RADIATION EXPOSURE DUE TO VENTING TMI-2  
REACTOR BUILDING ATMOSPHERE

A Study Prepared by the Institute for Energy and  
Environmental Research, Heidelberg\*, Federal Republic  
of Germany for the Three Mile Island Legal Fund,  
Washington, D.C.

Bernd Franke and Dieter Teufel

Heidelberg, June 12, 1980

Figure 1: Comparison of Atmospheric Dispersion Factor Calculated with Data Sets from Different Authors

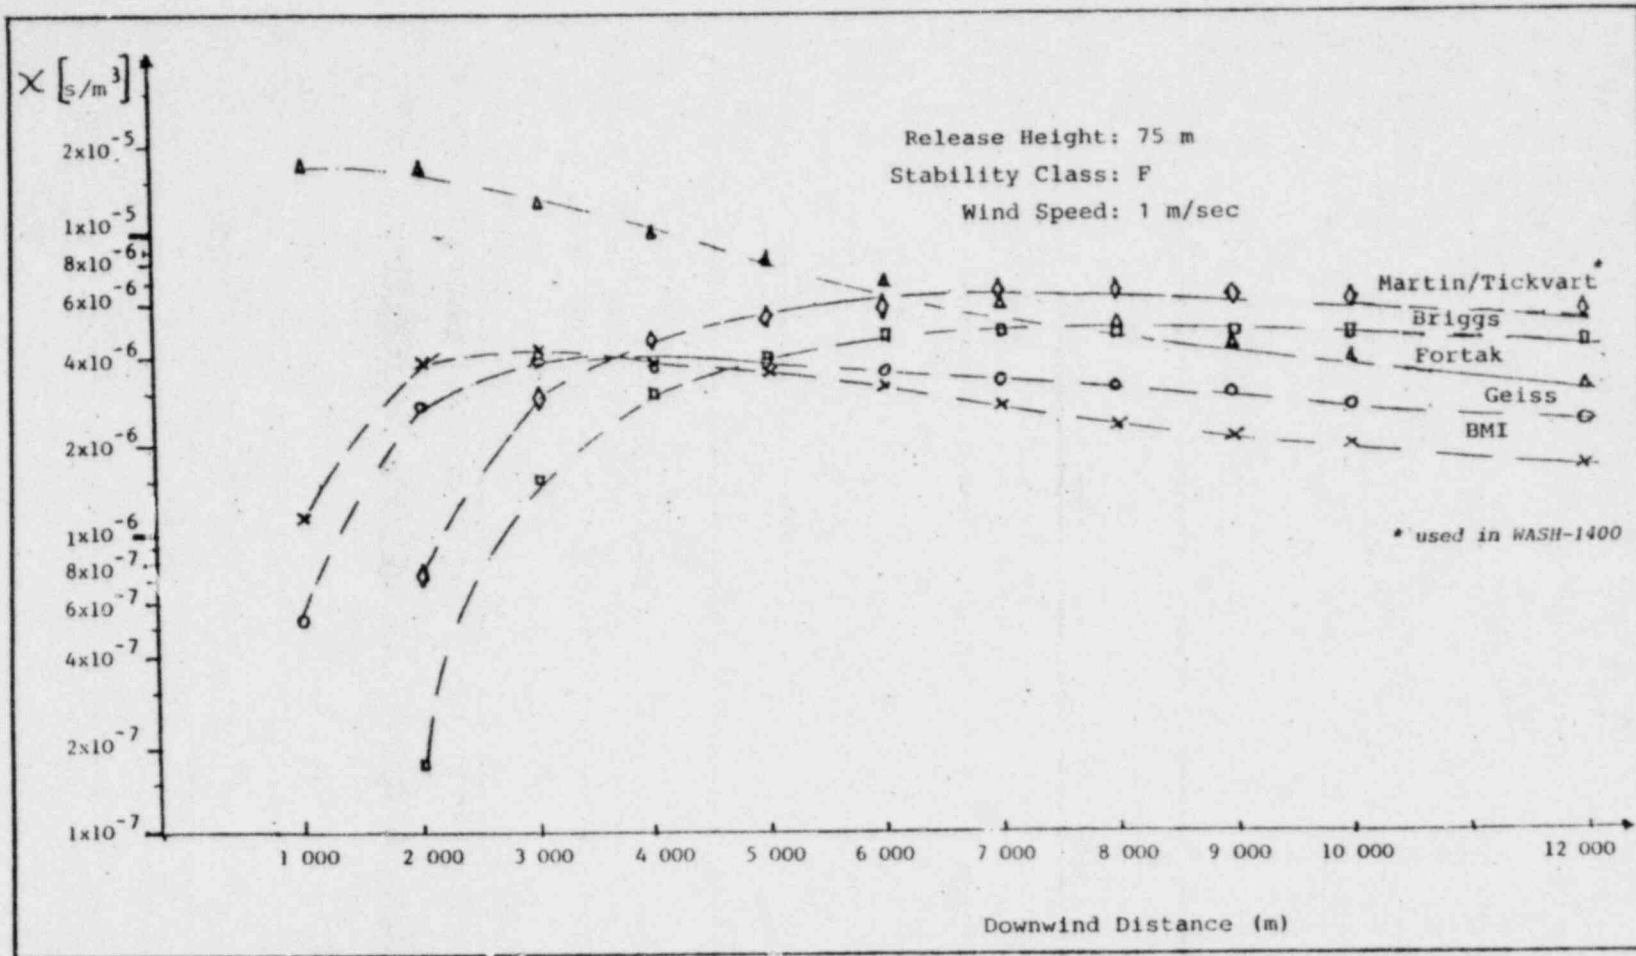
the meteorological dispersion factor  $\chi$  is computed in dependence of stability classes, wind speed and release height. However, it is clear that the data set used by Met Ed is not the only one available. Figure 1 shows the variation of meteorological dispersion as a function of the distance from a special weather situation and for certain distance from the emission source. When comparing the data sets from five different authors, we find a factor higher than 100 for  $\chi$  at 1 000 m downwind. For other meteorological situations, a smaller variation is found. Since each data set presents mean values originally derived from several measurements, there is an additional uncertainty of up to one order of magnitude. Therefore, the question of data sets is in fact highly relevant to whether or not Met Ed only releases under favourable weather conditions. We found that under all weather conditions Met Ed calculations may underestimate actual doses up to more than one order of magnitude.

The meteorological program proposed by Met Ed should ensure that environmental doses do not exceed the 10 mrem-limit skin dose. They do not, however, take the uncertainties described into account.

A more extensive investigation is necessary to eliminate these uncertainties and to give precise information about combination of meteorological parameters, under which beta skin doses of more than 10 mrem could be eliminated with low probability of error. With the present meteorological models and dose calculations, there are considerable doubts that the proposed venting program can exclude the possibility of individual skin doses due to Kr 85 exceeding the 10 mrem limit.

A solution of the problem of reducing the individual doses could be venting by a tethered balloon as suggested by UCS. Or, secondly, all persons could be evacuated from the vicinity of the plant during the release. A third solution would be not to release krypton into the atmosphere at all, but to use alternative methods of decontamination.
